SUNDRY	UNITED STATES EPARTMENT OF THE IN EUREAU OF LAND MANA NOTICES AND REPOI is form for proposals to ell. Use form 3160-3 (API	NTERIOR GEMENT HO		OMB N	APPROVED O. 1004-0135 July 31, 2010 or Tribe Name
	IPLICATE - Other instruc	tions on reverse side. REC	CEIVED	NMNM070928	ement, Name and/or No
Type of Well ☐ Gas Well ☐ Ot				8 Well Name and No COTTON DRAW	UNIT 154H

Devon Energy Production Co, LP respectfully request to change the Casing Program (see attached).

Cotton Draw Unit 154H Devon Energy Production Company 30-015-38952 Sep 22, 2011 Conditions of Approval

Design Parameter Factors:

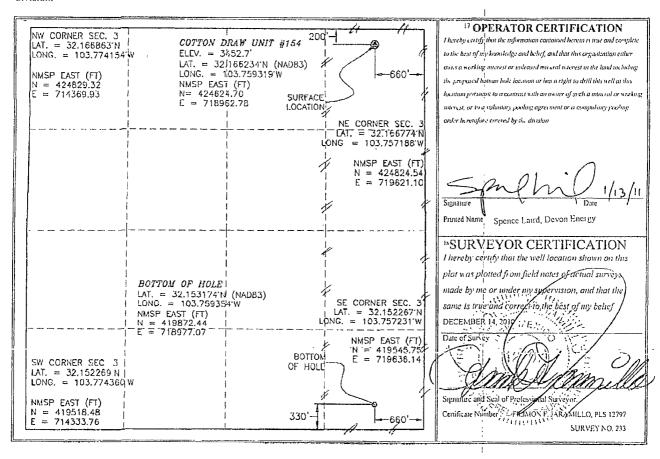
This is changing the weight of the casing from 20# to 17# per foot. Cement volumes will remain the same.

to revise casing program for the 5-1/2" casing. Segment "A" proposed to be changed from 20# to 17# weight per foot with coupling. Cement job design is stated unchanged.

Conditions of Approval:

- a) Request approved in compliance with original APD.
- b) Amount of cement slurry may require increase, since there is no excess cement in the design for obtaining TOC at 3800' to provide a 500' overlap to previous shoe.
